# Management and Staff Review And Recommendations

Renovation/Expansion Studies  
1995-2008

American Airlines Arena  
Miami, FL

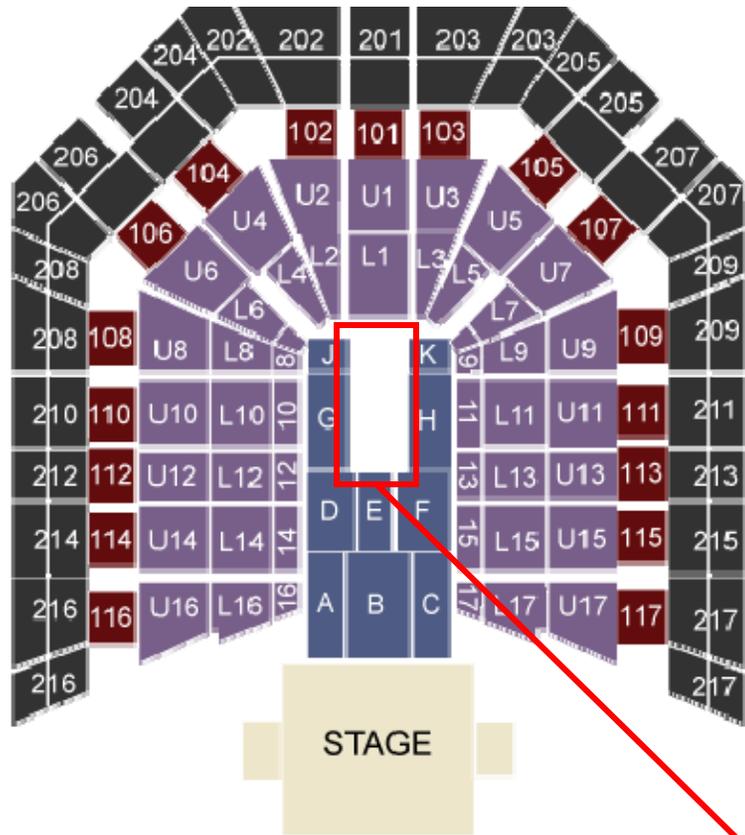
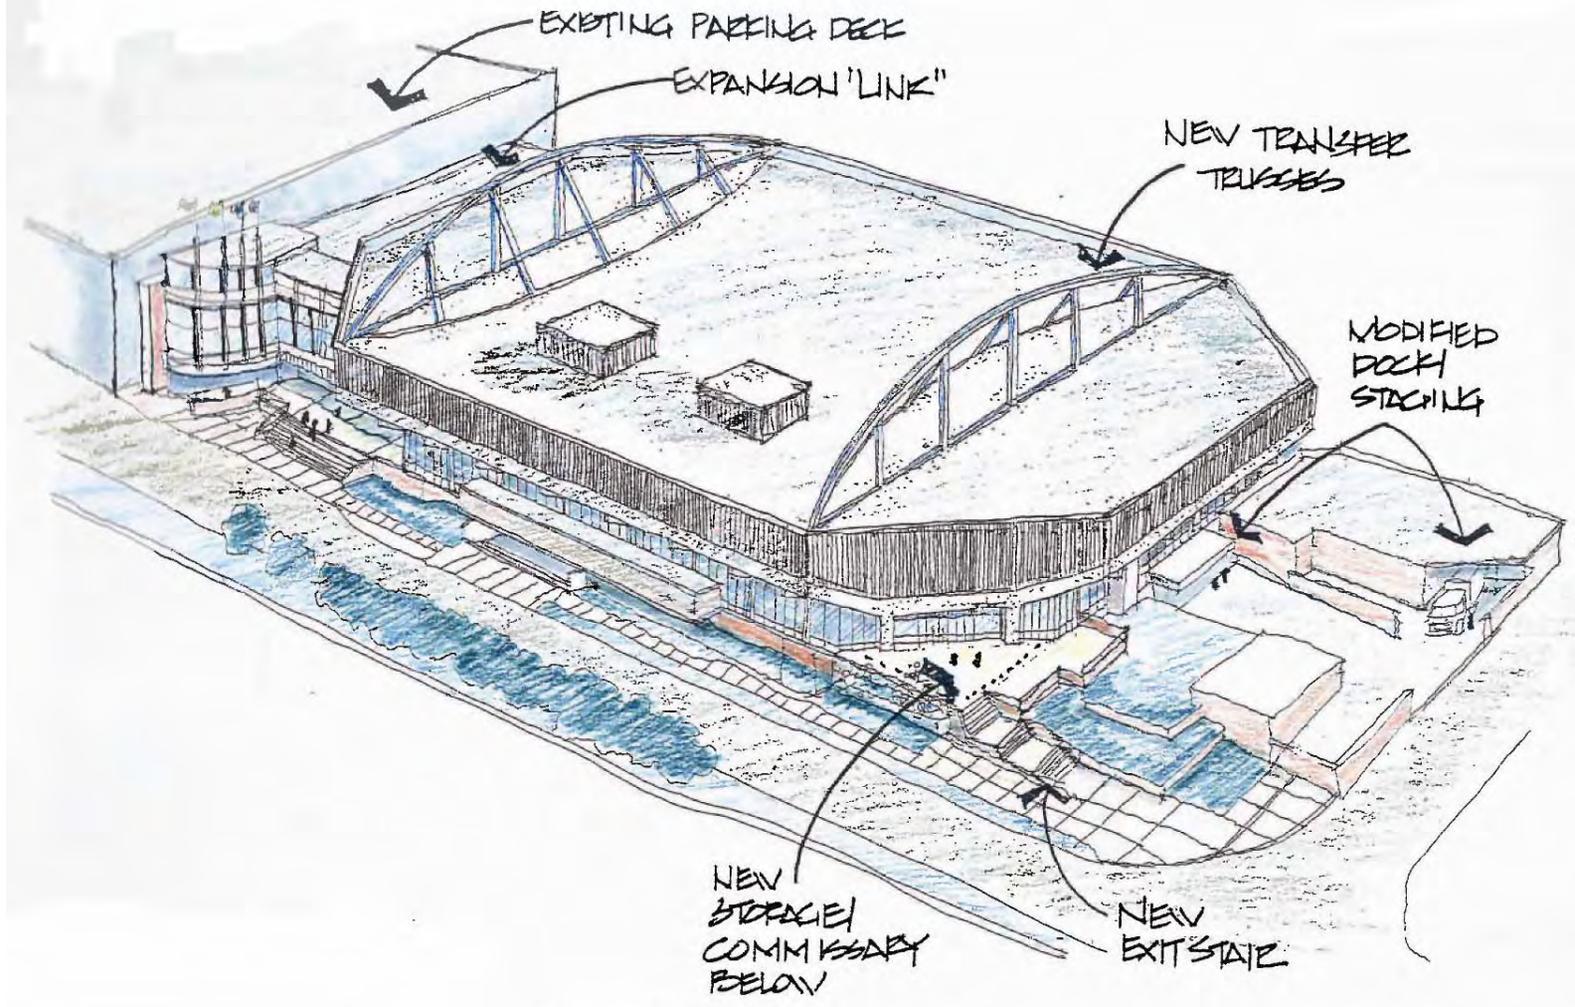
FOH Mix position creates an obstruction. Both venues "kill" seats directly behind FOH Mix as not viable

# Option C (Expansion/Revenue Driven Improvements) - Balcony Seating

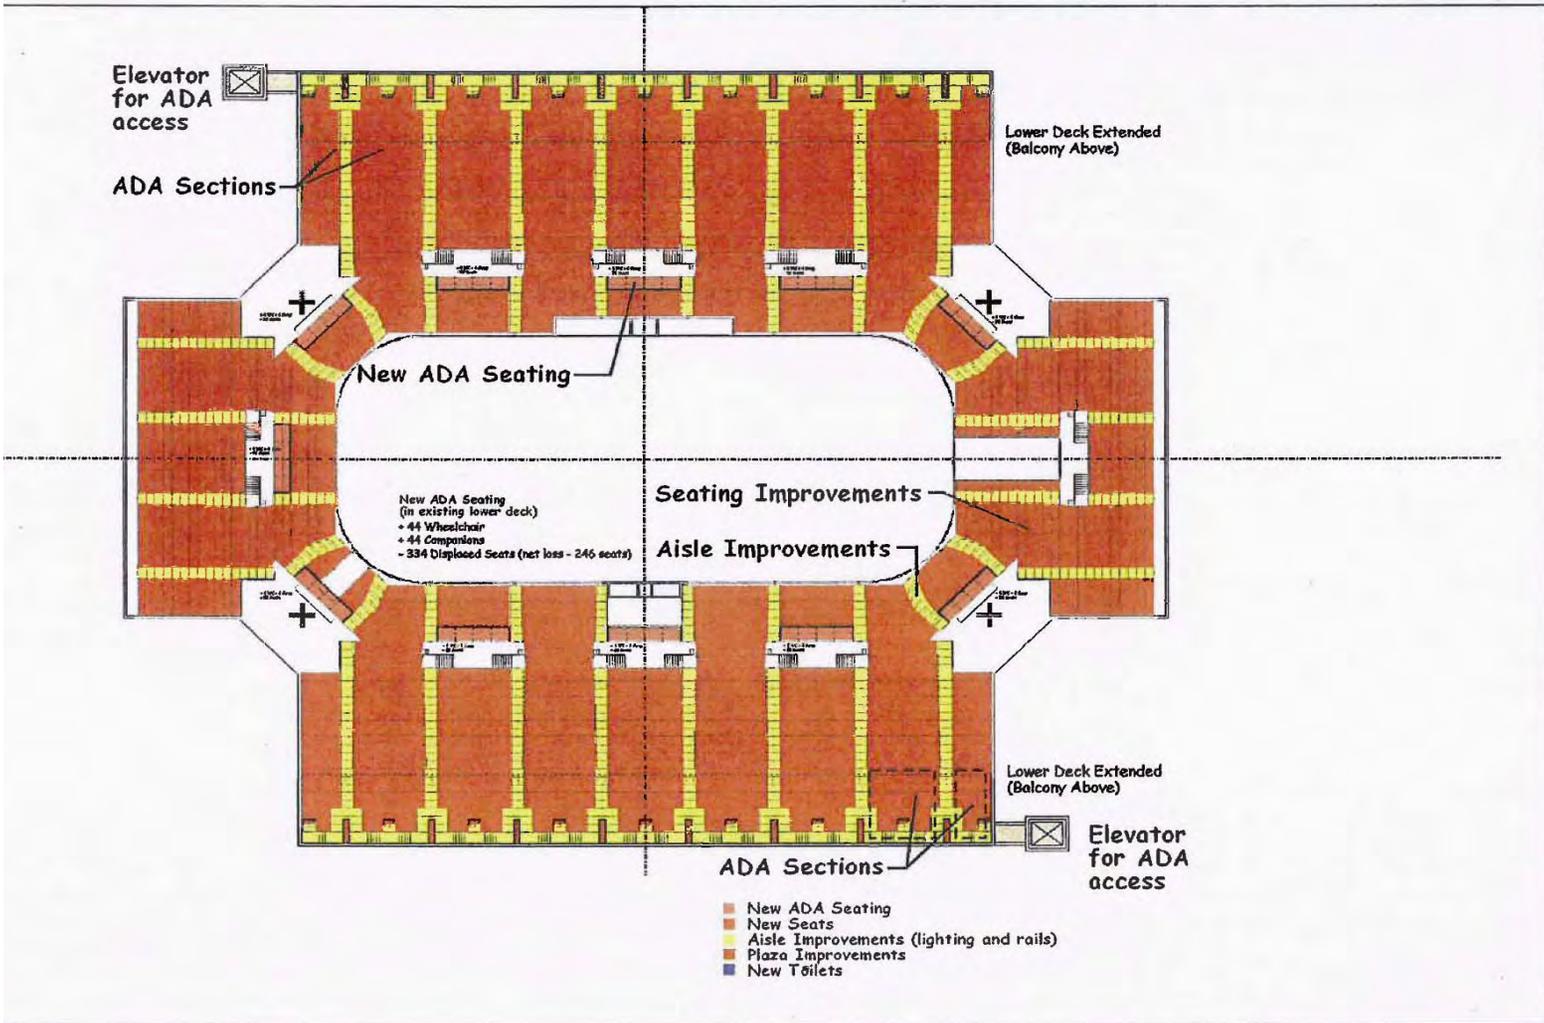
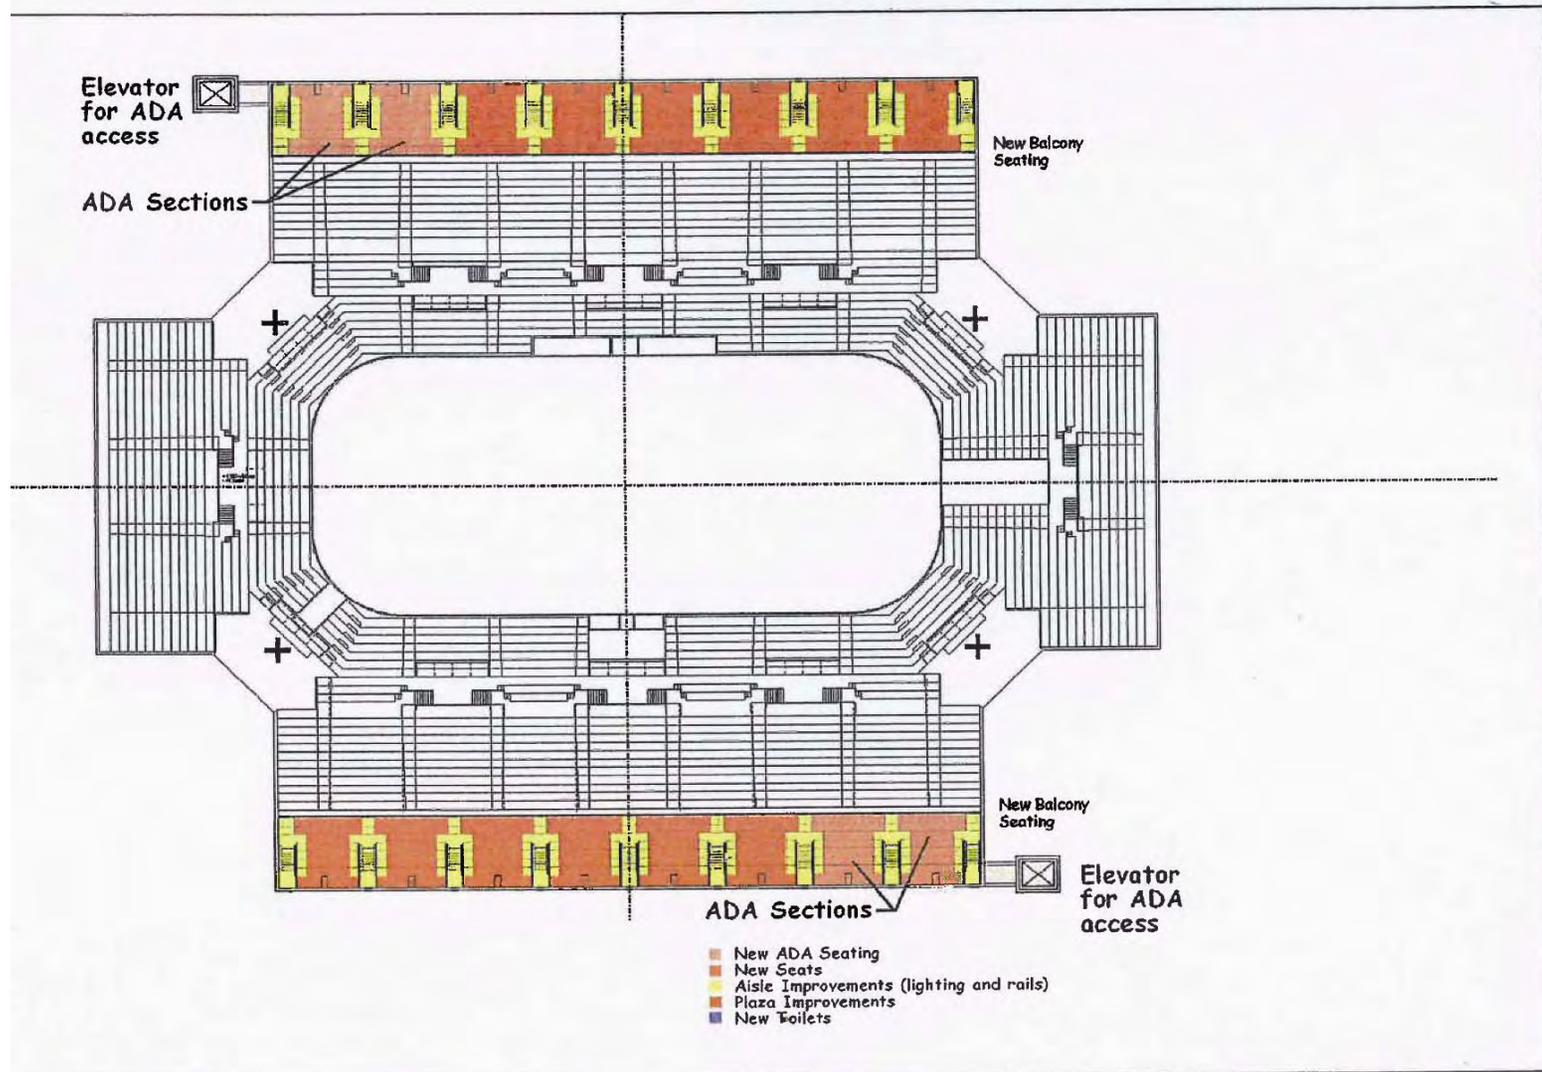
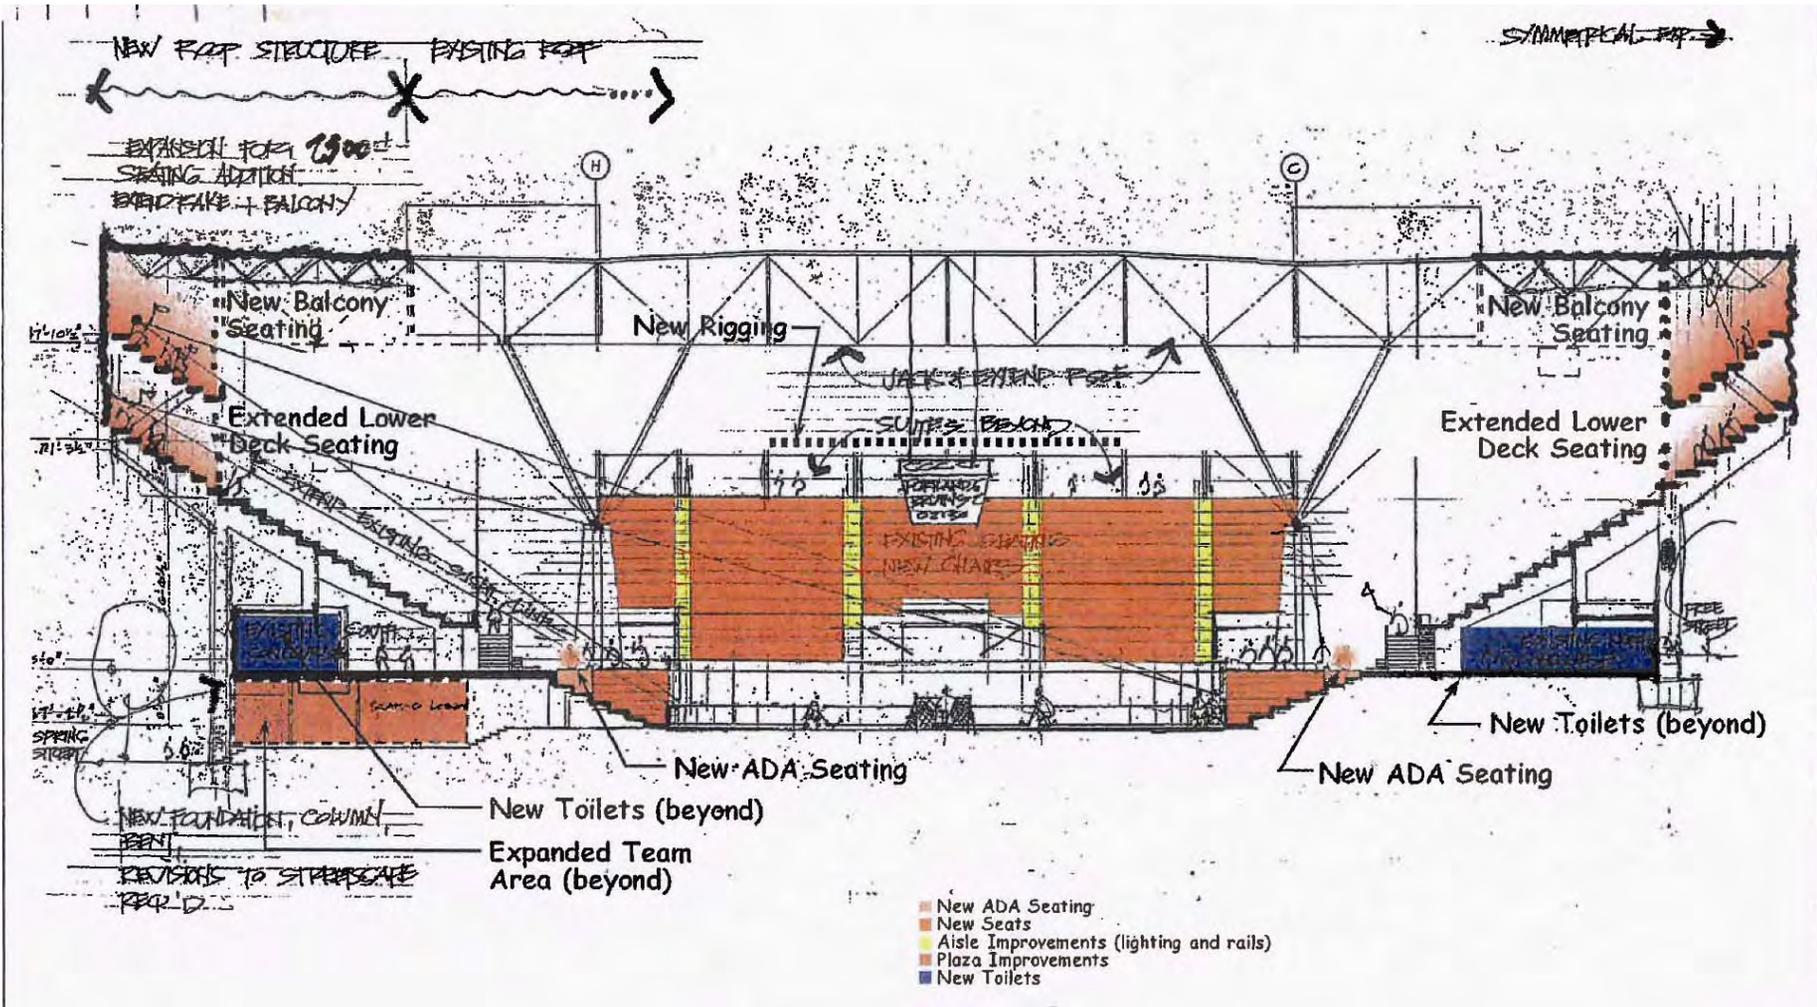
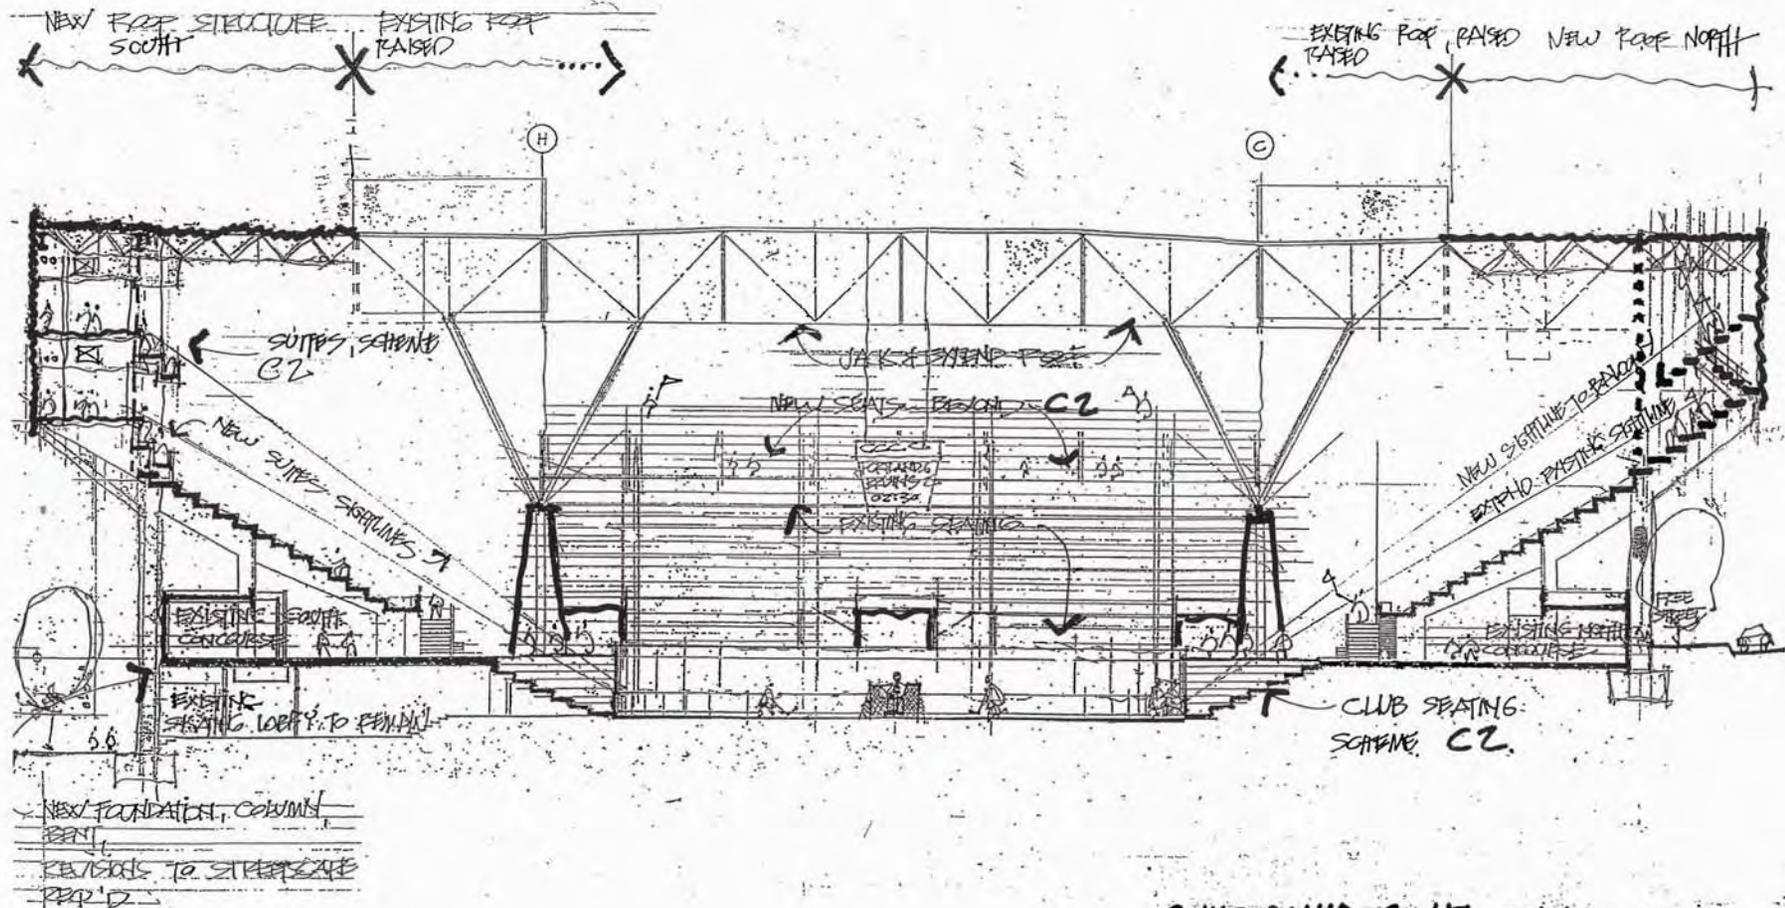
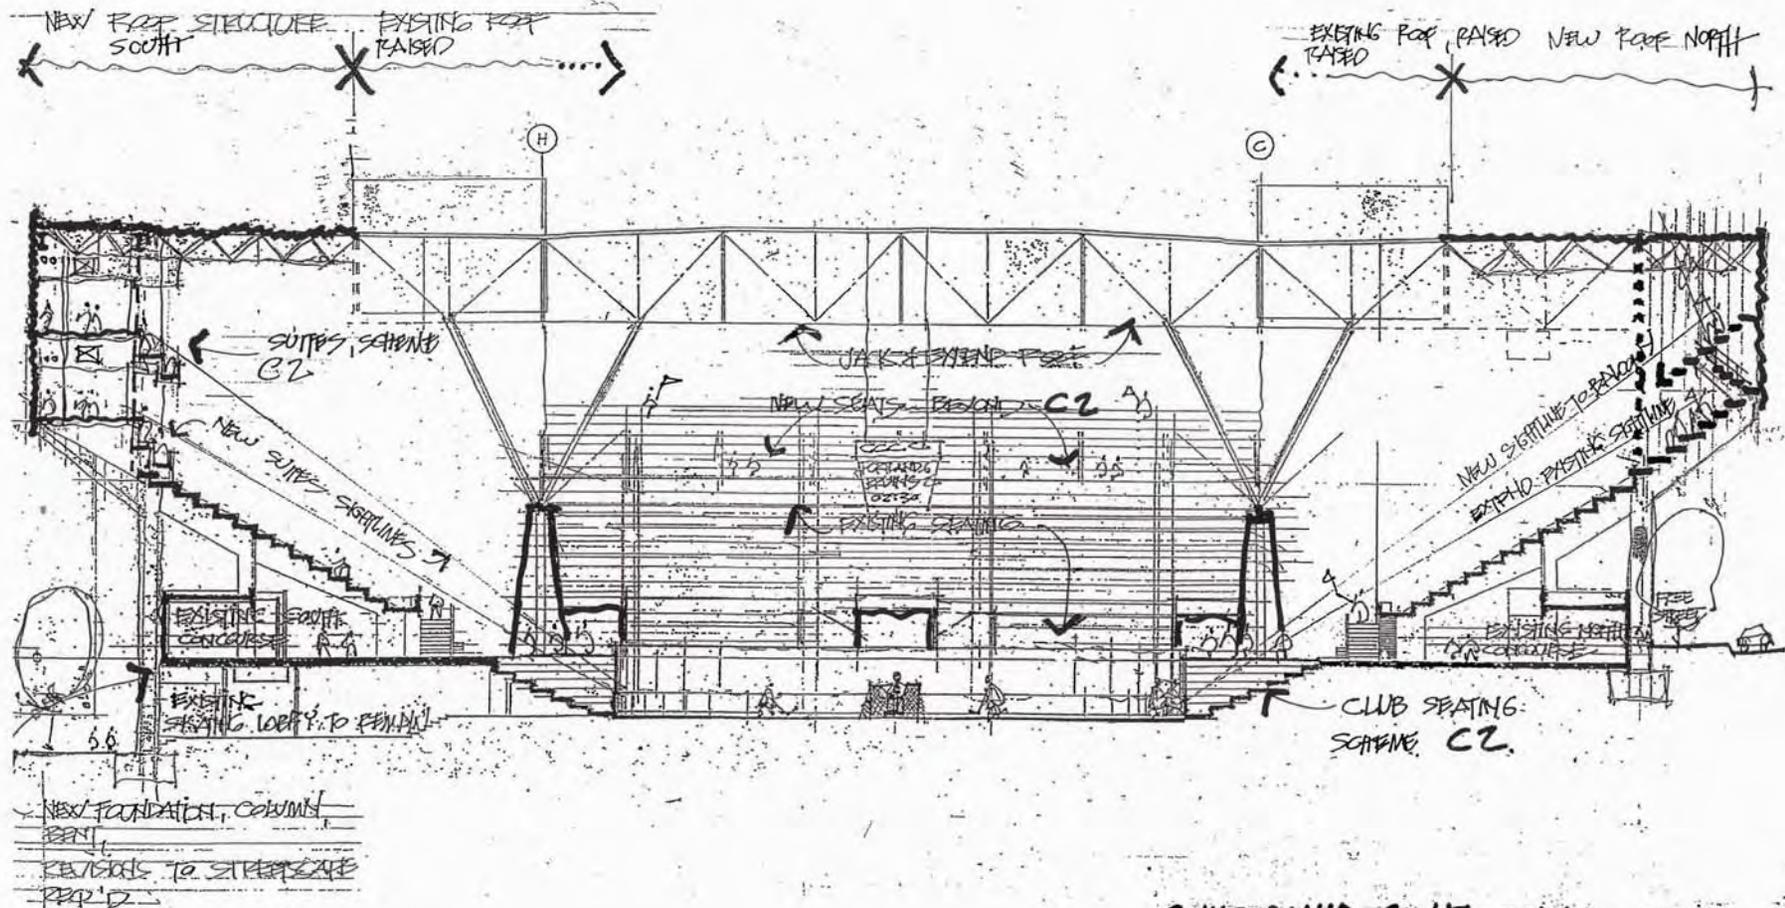
The O'Dell Study proposes hanging the roof off external arches, filling in the corners with seats and adding end-zone balconies. However, this only adds approximately 800 valid seats on the front stage end after ADA adjustments.

Heery proposes to jack the roof up and extend the existing seating cantilevers to add more seats at the existing stadium level. Heery also proposes to add lateral balconies. We estimate this to add approximately 1,500 seats to the front stage capacity. The drawback to both the Heery and O'Dell proposals is that it could require an extended closure of the facility

Steuver Bros. proposes an increase in capacity principally by the following method:

- The incorporation of retractable seating on the Center Street end allowing a stage setback to provide more floor space for folding chairs and to increase the seating in the stadium

We feel that several of the conclusions on the added capacity are flawed and that a thorough analysis needs to be done to determine the actual number of fixed seats that would be gained by the Steuver Bros. plan.
